5. Zoning By-law Amendment – 4775 and 4875 Spratt Road

Subject: Zoning By-law Amendment – 4775 and 4875 Spratt Road

File Number: ACS2022-PIE-PS-0032

Report to Planning Committee on 14 April 2022

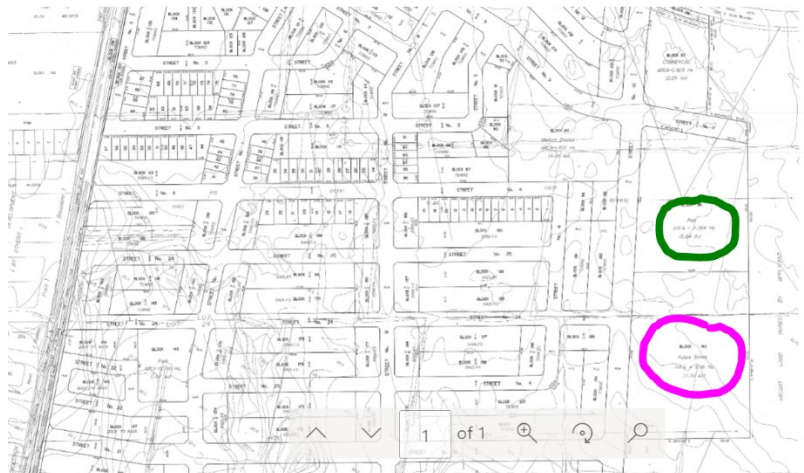
5. And can you locate the school for me? Is it on a main road, and what will be a busy road? Not ideal, given the traffic problems we are experiencing at other new school.

- The school will be on Ralph Hennesey, which is a collector road. Staff understand the concern about children walking to school and wanting schools on local roads, but it has been determined that schools are best placed on collector's - so that they can accommodate the traffic that will be generated by school buses, school staff and parents. If a school is placed on a local street - it would make the local street much more challenging because they are not designed to handle the same capacity of vehicles. The school is the pink circle below and the park is the green circle.
